**SUBJECT:** **DELIVERY HOLD - Customer Satisfaction Program 16B11**  
Certain 2016 Model Year Fiesta ST and 1.0L EcoBoost Vehicles  
High Speed Cooling Fan Relay Replacement

## CERTAIN 2016 MODEL YEAR FIESTA ST AND 1.0L ECOBOOST VEHICLES — HIGH SPEED COOLING FAN RELAY REPLACEMENT

FIGURE 1

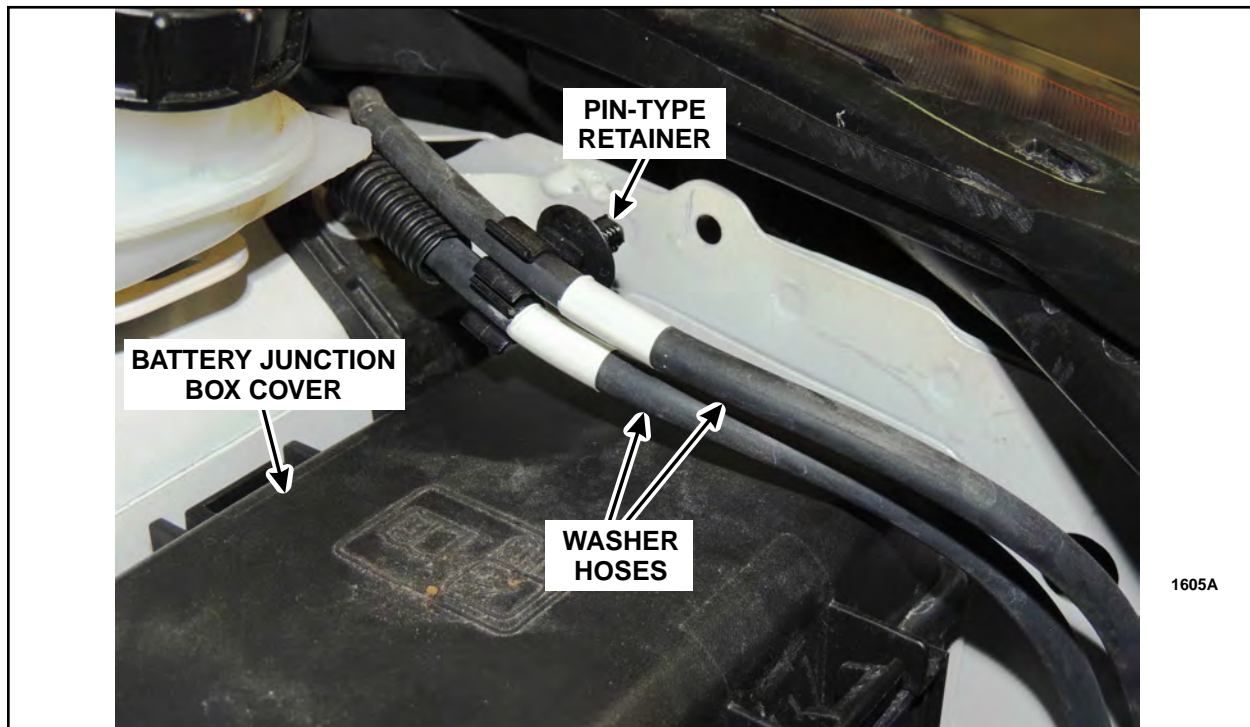
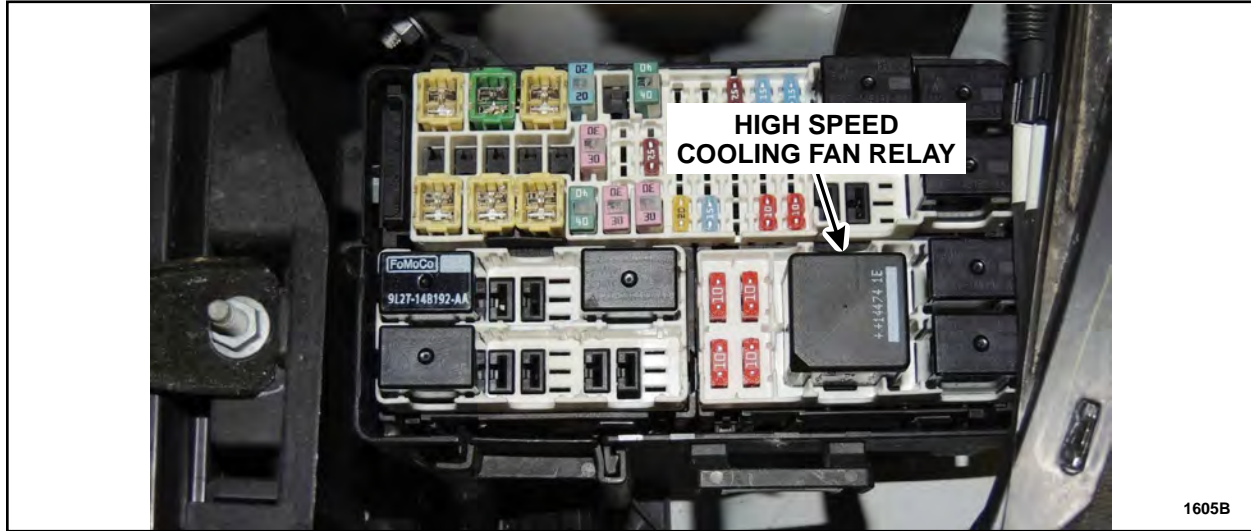
1. Release the pin-type retainer and position aside the washer hoses. See Figure 1.
2. Remove the battery junction box cover. See Figure 1.

3. Remove the incorrect high speed cooling fan relay. See Figure 2.

4. Install the *new* high speed cooling fan relay. See Figure 3.

Dealers are to install the correct high speed cooling fan relay.
